Aberdeen Offshore Wind Farm (European Offshore Wind Deployment Centre)

Introduction to Environmental Statement Addendum and Rochdale Adjustments

Rochdale Envelope Scenario 1:

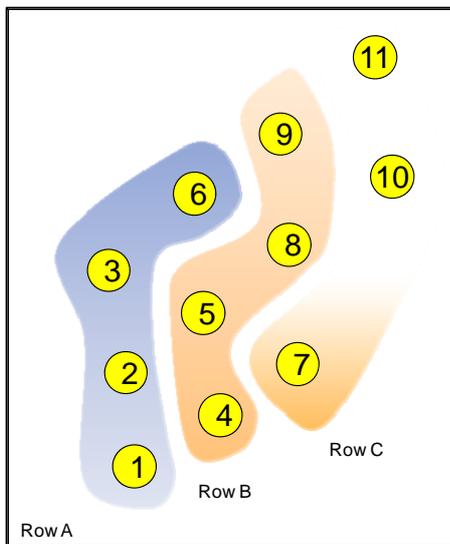
- 44 We have translated the objectives/principles into zoning of turbine dimensions by row location, and can confirm that none of the larger turbines would be located on the shoreward array of turbines (locations 1-6). The largest turbines would be located in locations 7, 8, 9, 10 or 11 (known as Row C in Scenario 3). The smallest turbines would be located on turbines 1, 2, 3 and potentially turbine 6 (Row A). The mid row B would contain turbines between the smallest and largest turbines.

- 48 We have attempted to present the zoning diagrammatically below. These scenarios are not definitive but we believe represent a Rochdale envelope in terms of landscape and visual effects, which includes the maximum and minimum likely scenarios with respect to the balance of the larger/mid range and smaller turbines. These scenarios have been used to re-assess the likely adjusted Rochdale envelope effects in order to demonstrate whether there are levels of perceptible change compared to the original Rochdale envelope as submitted.

Parameter	Tip height range	Maximum Hub ht (provisional)	Rotor diameter range
Row A	158 -180.5m	90 - 110m	128 - 135m
Row B	181 -190.5m	90 - 115m	150 - 165m
Row C	191 -198.5 m	90 - 120m	165 - 172m

Rochdale Envelope Scenario 2:¹

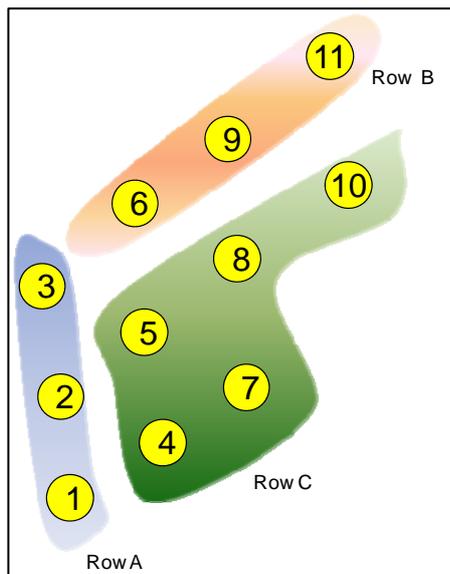
¹ Please be aware that location no 5 has specific wind constraints and may require a mid range turbine rather than a larger turbine.
